Crystal Palace Parade Junction Improvement Scheme

Consultation Summary

January 2015

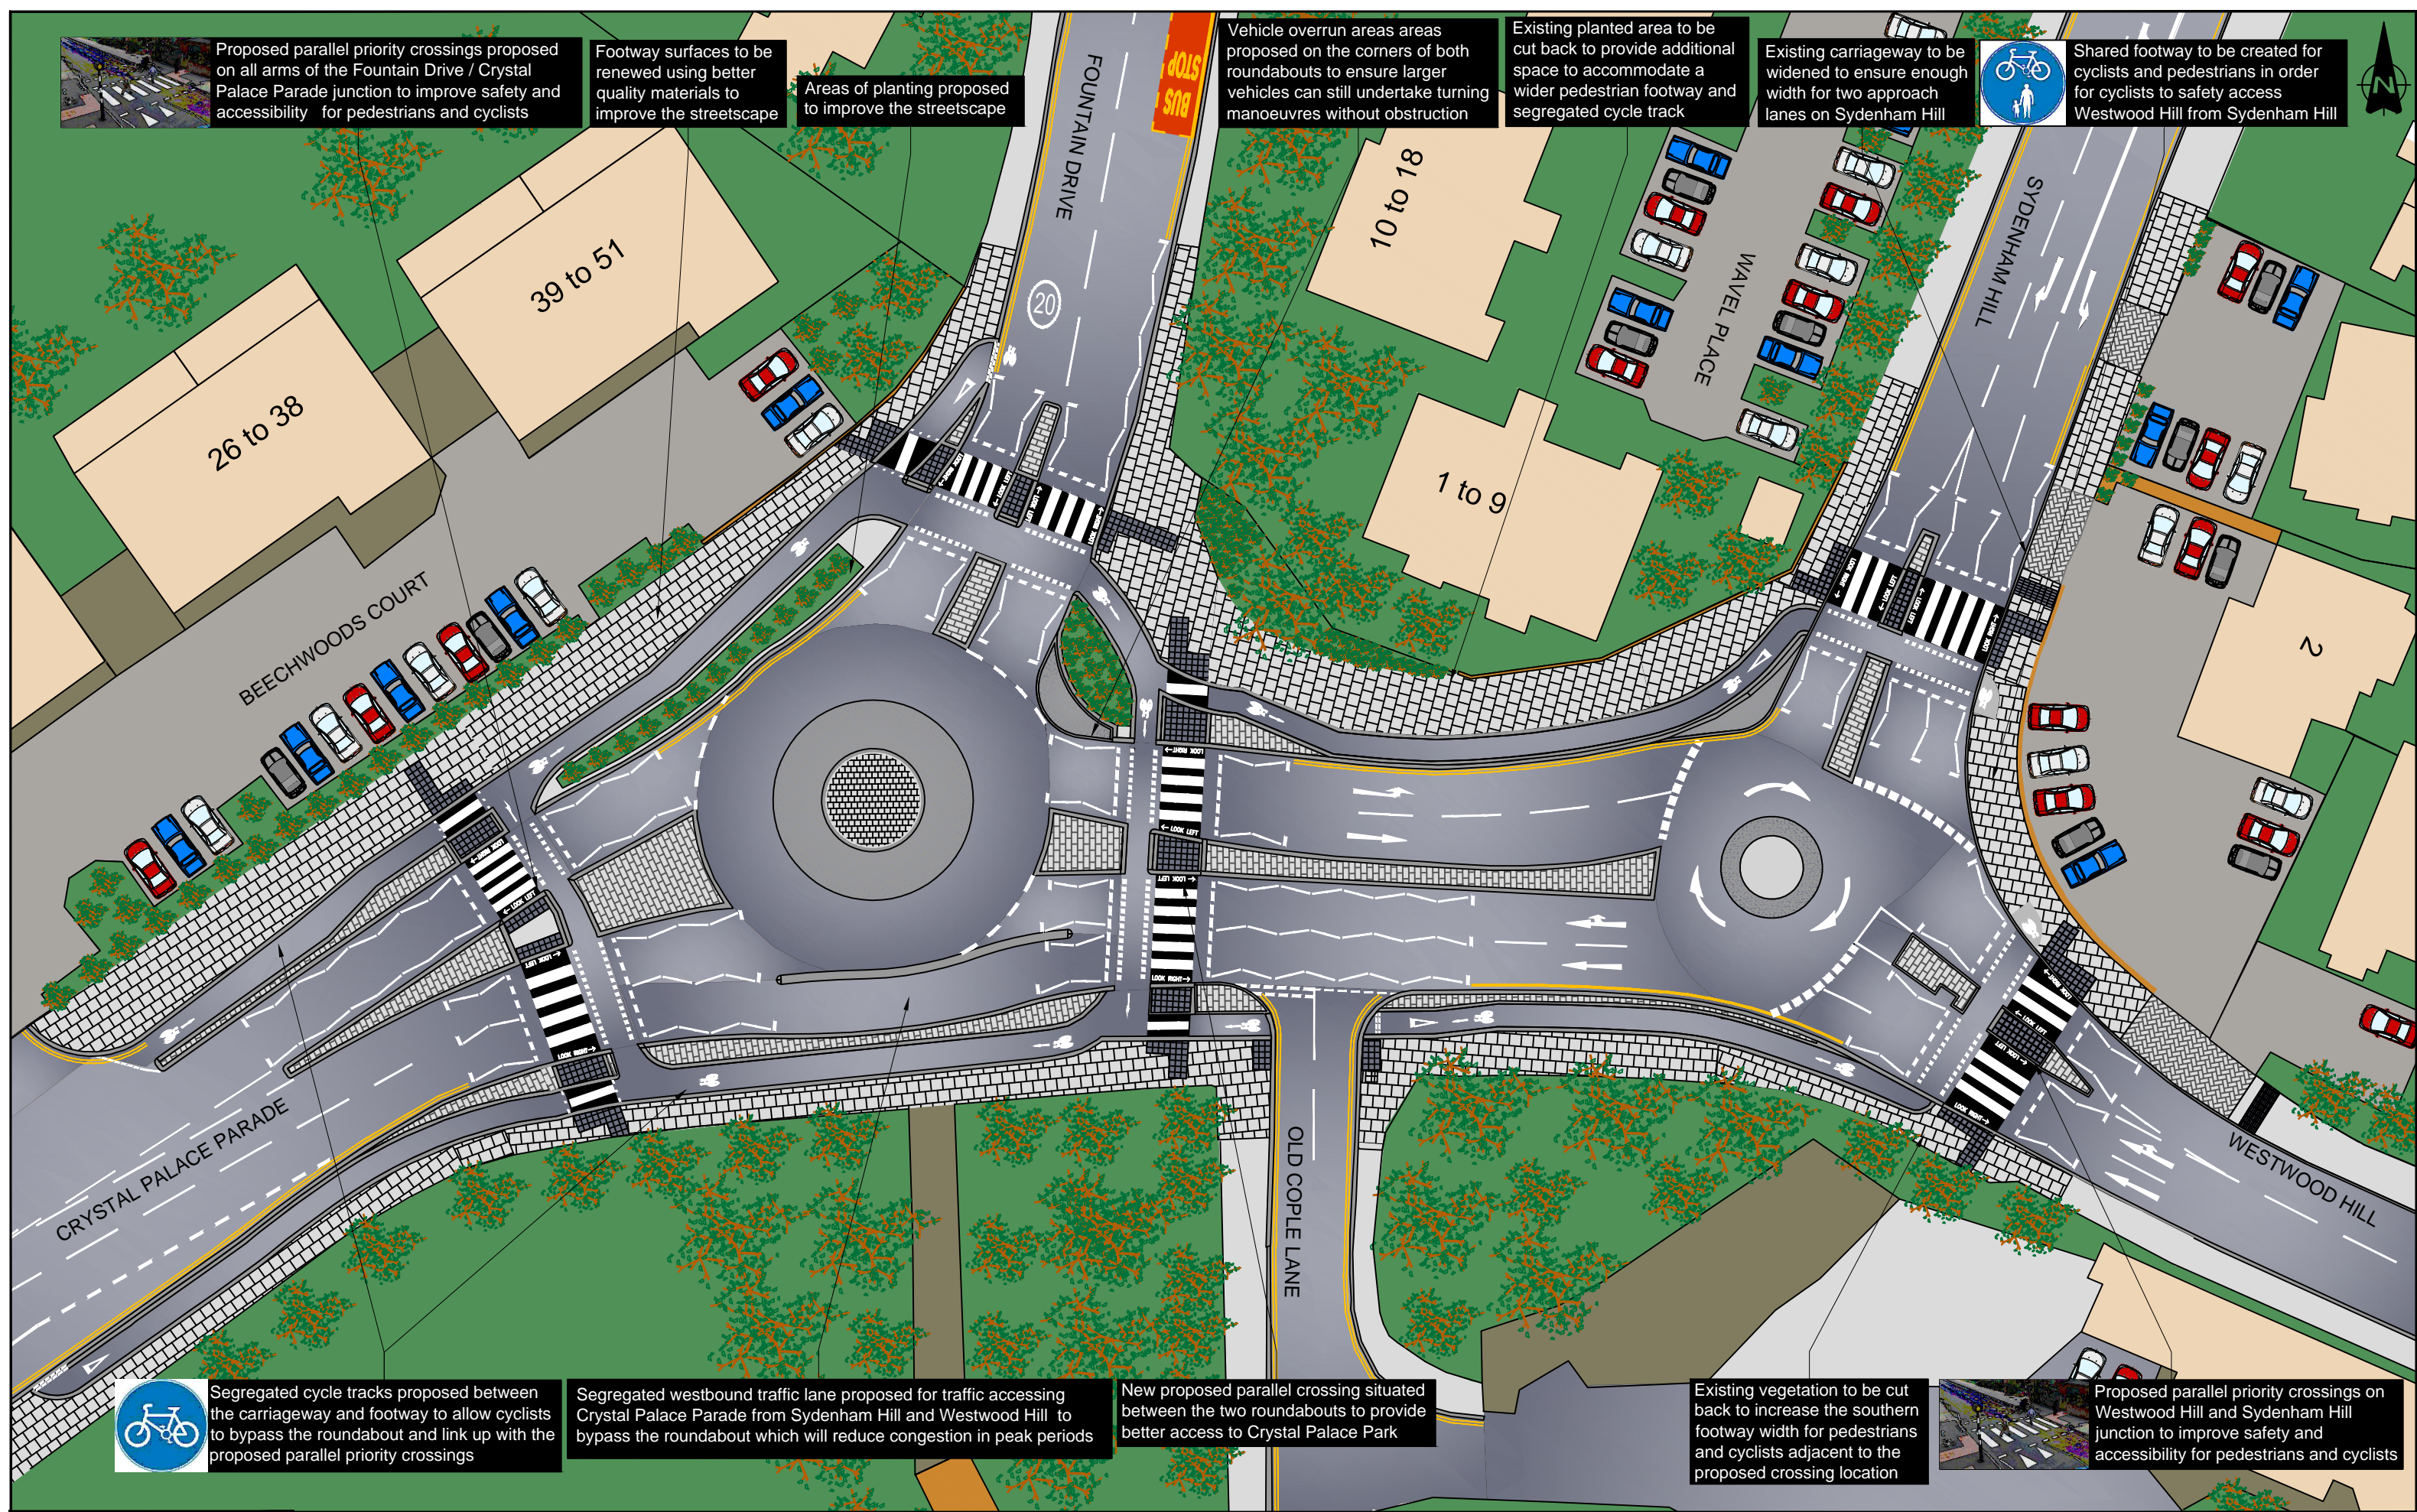
Existing planted area to be cut back to provide additional space to accommodate a wider pedestrian footway and segregated cycle track

Existing carriageway to be widened to ensure enough width for two approach lanes on Sydenham Hill

New proposed parallel crossing situated between the two roundabouts to provide better access to Crystal Palace Park
